Product Alert

Type of Notification: Performance Related Concern

Model: Figure 1075 fire safe safety shutoff valve

**Subject: Product Announcement regarding Jamesbury FM approved Figure 1075
Emergency Shutoff and Fire Safe Valves and Torq-Handle® Spring-Return Handles**

Figure 1: Configuration of product prior to 2002 - No action required

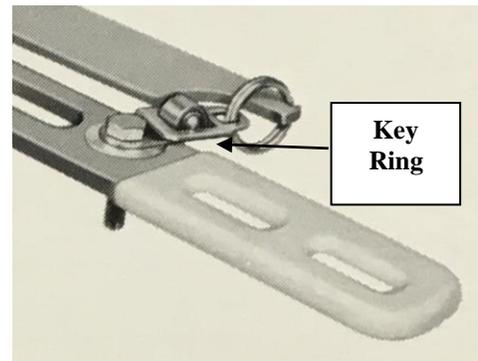
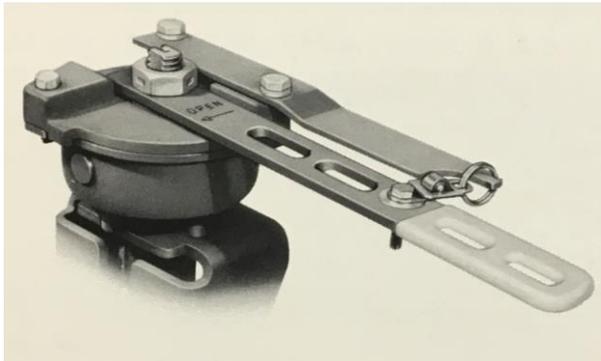
Note: Key ring around bracket secures end of fusible link

Figure 2: Configuration of product circa 2002 to today - Action required

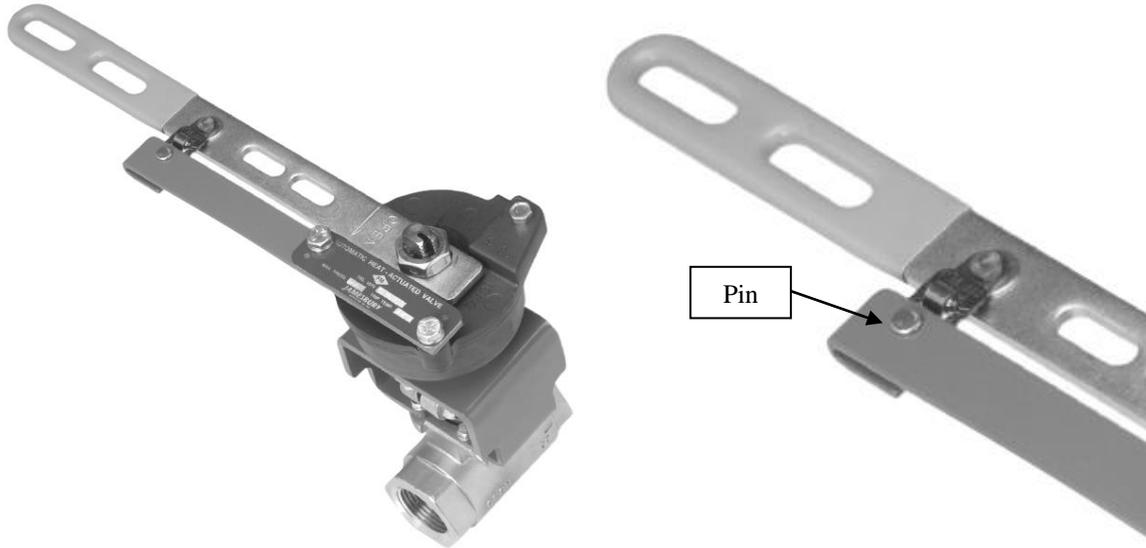
Note: Pin through bracket secures end of fusible link

If you have product matching the Figure 2 configuration, please contact Neles for replacement parts by sending an email to the below address. In the email, please identify the number of units requiring retrofit as well as the shipping address for the replacement parts:

As soon as replacement parts are received from Neles, please cycle the valve as recommended in the maintenance section of IMO-71 and secure the fusible link to the handle with the replacement parts per the instructions in Enclosure 1.

FIGURE 1

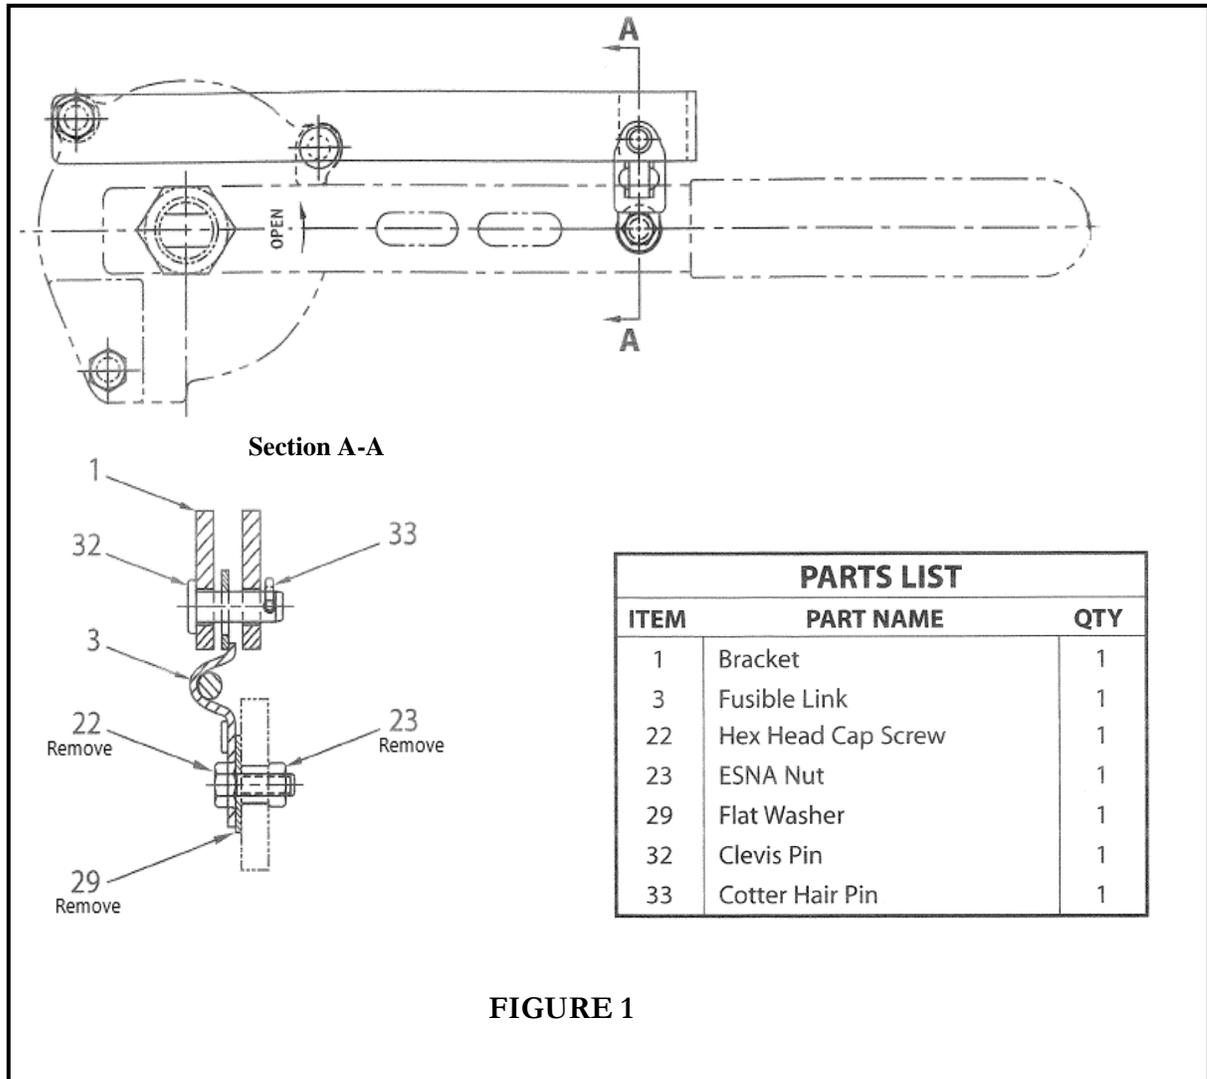
5. The current configuration is shown in Figure 1. Retrofit entails removing and replacing parts 22, 23 and 29, which connect the fusible link to the spring-loaded handle.
6. Hold the handle in position manually or with secure clamps, and remove parts 22, 23 and 29. Discard as these will not be used.
7. Install new clevis pin (32), spacer (34), and cotter pin (33) as shown in Figure 2.

FIGURE 2

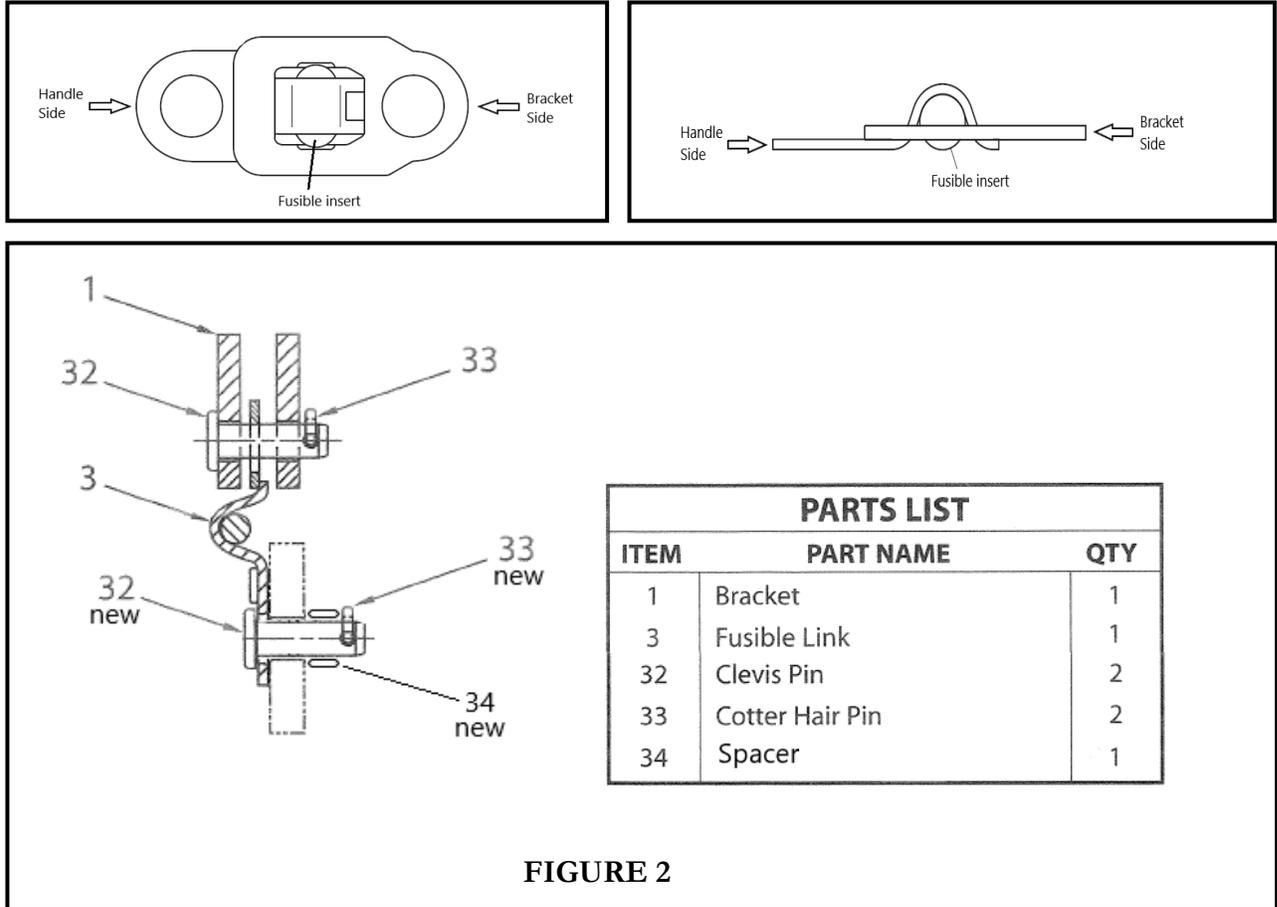
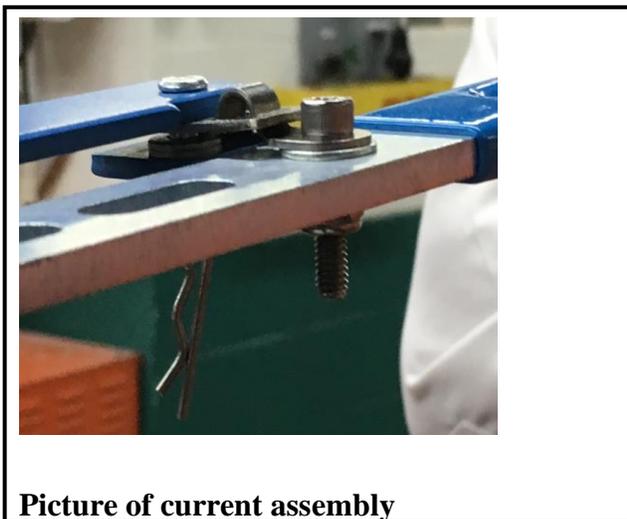
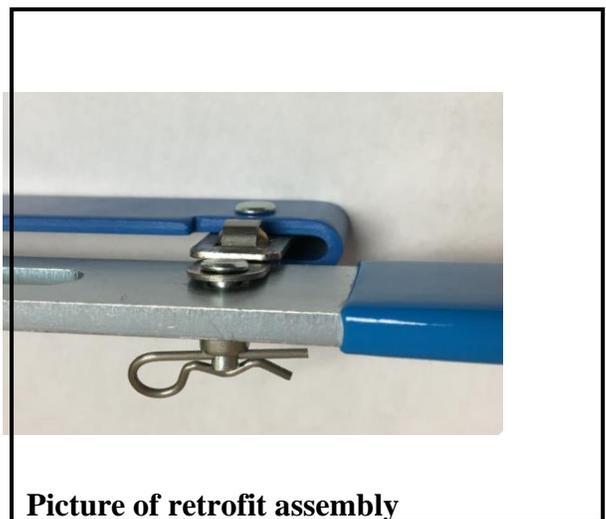
NOTE: There should be no additional washers or parts installed to hold the fusible link other than those shown in the parts list in Figure 2.

CAUTION: Ensure the fusible link is installed as shown. If installed opposite, the handle can interfere with dropping of the fusible insert when it melts.
